CARMEL DAM
(WEST BRANCH RESERVOIR)

PUTNAM COUNTY, NEW YORK
INVENTORY NO. 29

PHASE I INSPECTION REPORT
NATIONAL DAM SAFETY PROGRAM

LOCATIONS OF OBSERVATIONS
WEST BRANCH RESERVOIR
MAIN CARMEL DAM
NOT TO SCALE

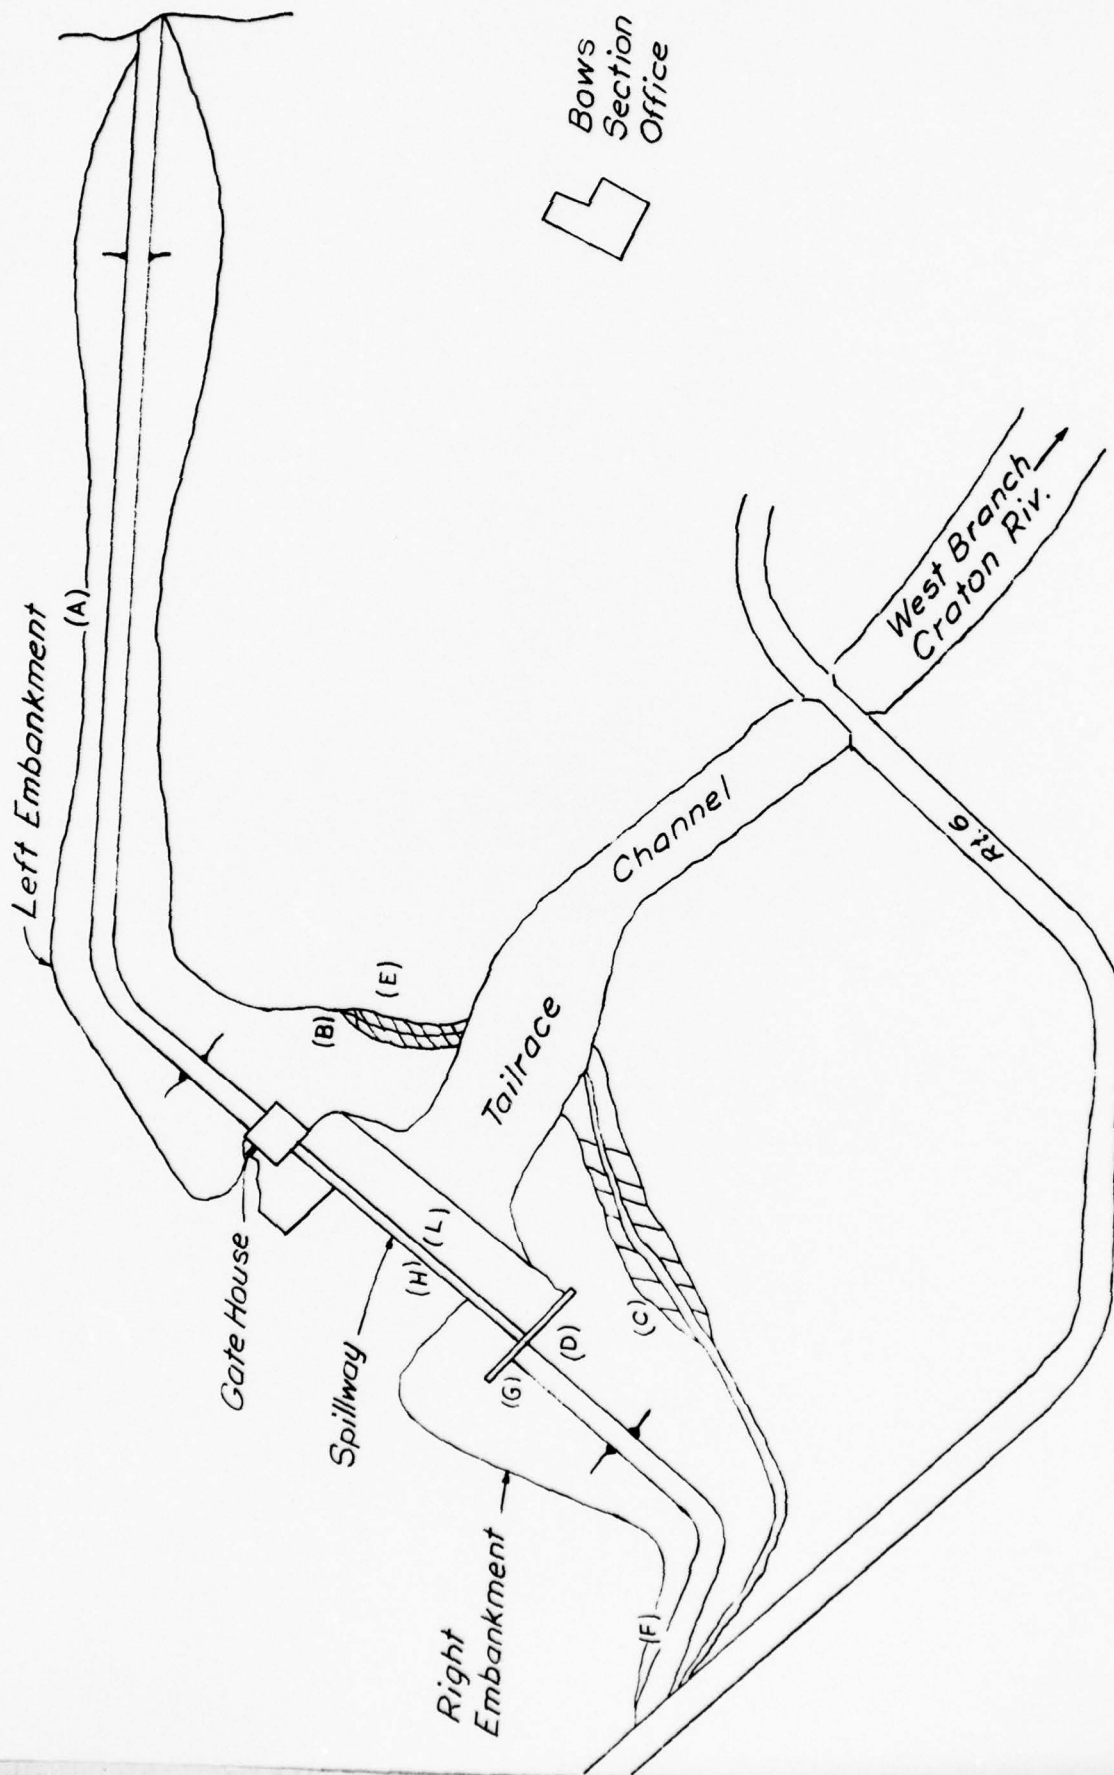
(A) Trees are growing near and at the upstream toe of the left embankment.

(B) Seepage emerges from the lower portion of the abutment contact of the left embankment. The water appears near the old paved collector ditch and flows in and near the ditch. The surface of the embankment and abutment in the area of seepage is wet and soggy. The embankment surface shows minor irregularities which are thought to be made by the maintenance tractor in the wet ground. Because of the soggy surface the vegetation was not cut in the area.

(C) Wet, soggy ground exists but no seepage water appears at the lower part of the abutment contact of the right embankment. Surface irregularities similar to those found at the left abutment were also noted here.

(D) Some bushes are growing on the downstream slope of the right embankment near the spillway wall.

(E) There are some animal burrows (approximately 8-in. in diameter) on the left abutment near the embankment contact.

(F) Minor damage has been noted in the stone slope protection at the far right end of the right embankment.

(G) The upstream stone slope protection has developed a depression and a bulge to the right of the spillway. In this area there is a crack in the slope protection which is associated with the slight downward movement of the stones.

(L) Although the inspection was made at a time when the reservoir level was below spillway crest, considerable amounts of water were cascading on the downstream face of the spillway. The water emerged from between the joints of stones facing the spillway at all levels but the heaviest flow came from the joints of the top 2 or 3 layers.

(M) The top two layers of surface stones have been dislocated from their original position and pushed (probably by ice) downstream. The alignment of these two rows of stones has a downstream curvature.

- a. The stonework, serving as spillway facing needs to be repaired in order to correct the seepage condition noted at locations (L) and (M).
- b. The seepage and wet conditions noted at locations (B) and (C) should be systematically observed and possibly corrected by trench drains or protected by filter blankets.

- e. The following measures can be carried out as part of the maintenance work: Removing trees and bushes, repairing minor damage and erosion of slope protection, clearing debris, and treating animal burrows. (Locations (A), (D), (E), (G), (I) and (K)).

- f. Some of the observations, such as the minor upstream slope protection damages at locations (F) and (J) do not require any action at present, however periodic observations are recommended to detect potential further deterioration in the future.

LOCATIONS OF OBSERVATIONS
WEST BRANCH RESERVOIR
AUXILIARY DAM
NOT TO SCALE

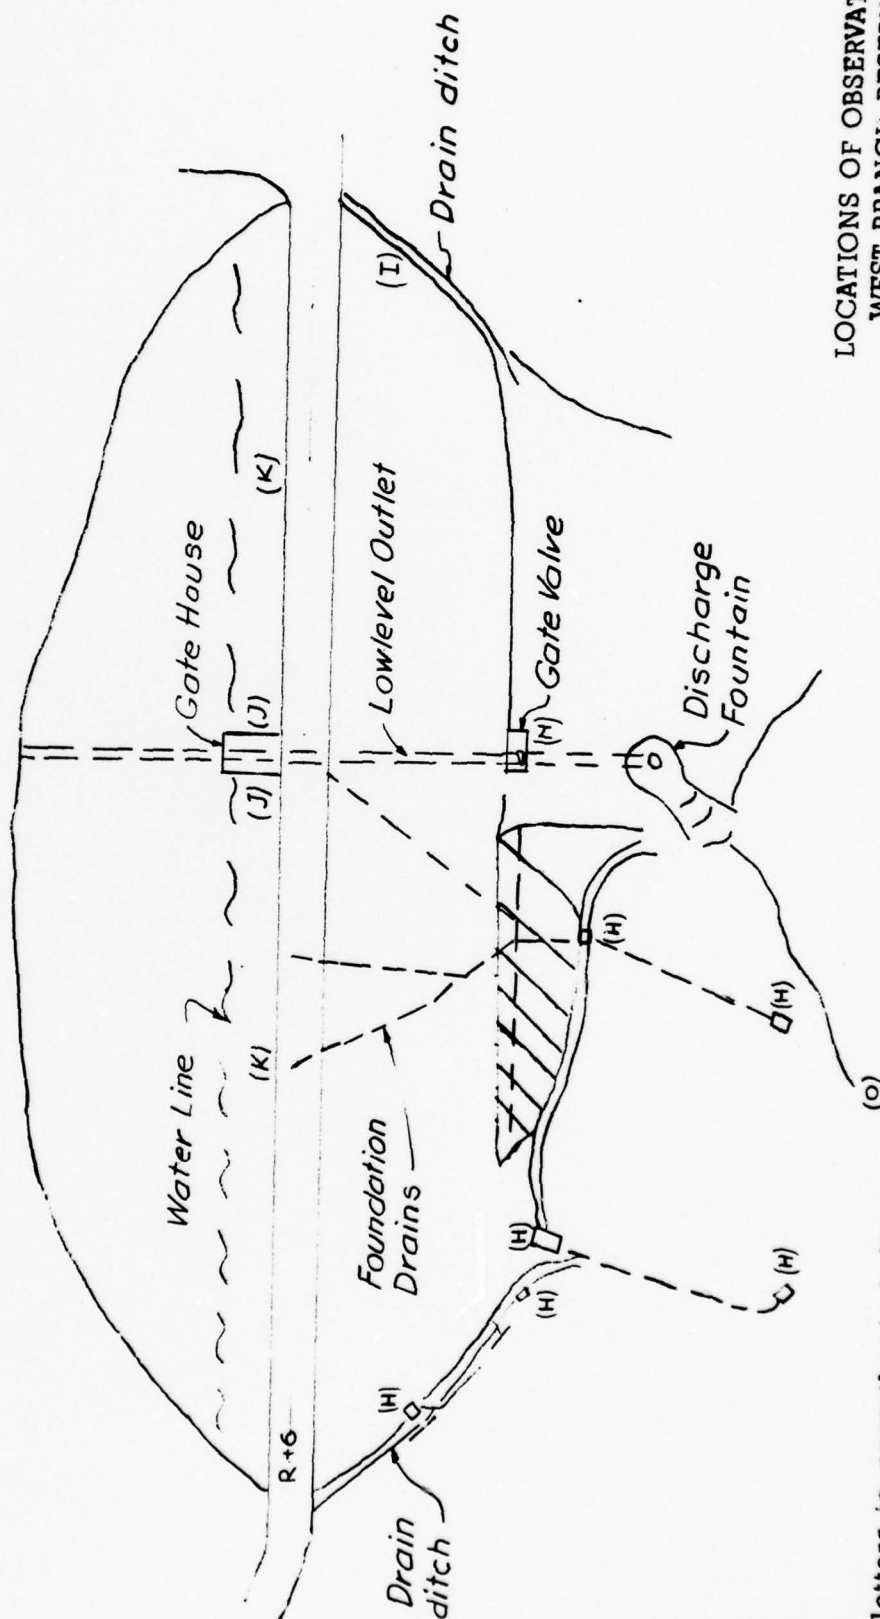
(H) The access vaults and manholes of the drain system are partially clogged with debris, sand and leaves. The seepage measuring weirs of the system are not operational.

(I) There is minor erosion made by surface runoff from the highway on the downstream slope near the left abutment contact.

(J) The stone protection on the upstream slope has developed some minor damage on both sides of the gate house.

(K) Some saplings and bushes are growing on the upstream slope.

(N) The 36-in. gate valve at the auxiliary dam is broken and stuck in a partially open position.

- c. The drain system of the Auxiliary Dam should be cleaned and new seepage measuring devices installed (Location (H)).
- d. The 36-in. gate valve at Auxiliary Dam should be repaired (Location (N)).
